Letter of Explanation

Subject Property: 2104 Bromley Ct., Crofton MD 21114

Variance Case Number 2023-0158-V - 2104 Bromley Court - clarifying questions

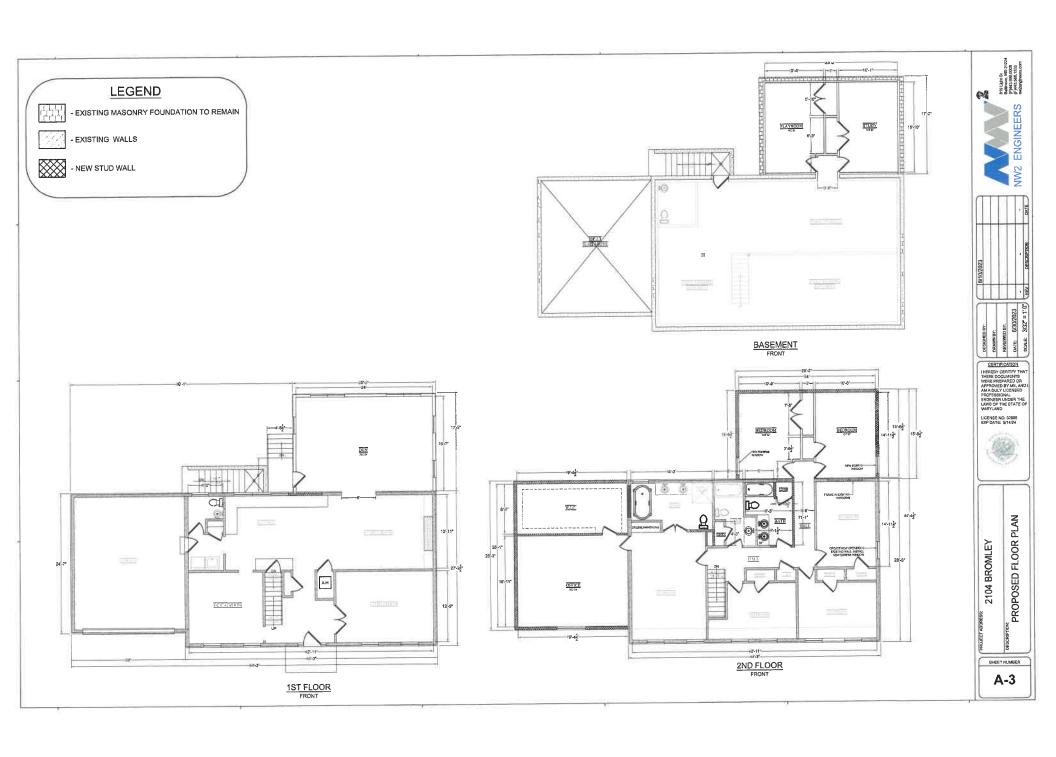
First, the patio (between the pavilion and the addition to the dwelling) is proposed at-grade, correct?

Second, what are the dimensions of the proposed pavilion, including height?

Third, can you confirm that I am reading the distance markings correctly?:

- 1, from the side addition to the side lot line, as close as 12 feet +/-;
- 2. from the pavilion to the rear lot line, as close as 3 feet 7 inches; and
- 3. from the rear addition to the northeasterly lot line, as close as 14 feet 2 inches?

Yes the patio is proposed at grade. More specifically, it is proposed to be at the level where the basement walls out into the backyard.

Dimensions of the pavilion: 12' x 14' and 10' high at the center.

- 1. This is true, but please note that the side addition is actually over an existing garage.
- 2. The post of the pavilion to the rear lot line is actually proposed to be something more like 6' 5' from the rear lot line.
- 3. Yes, I believe this to be true
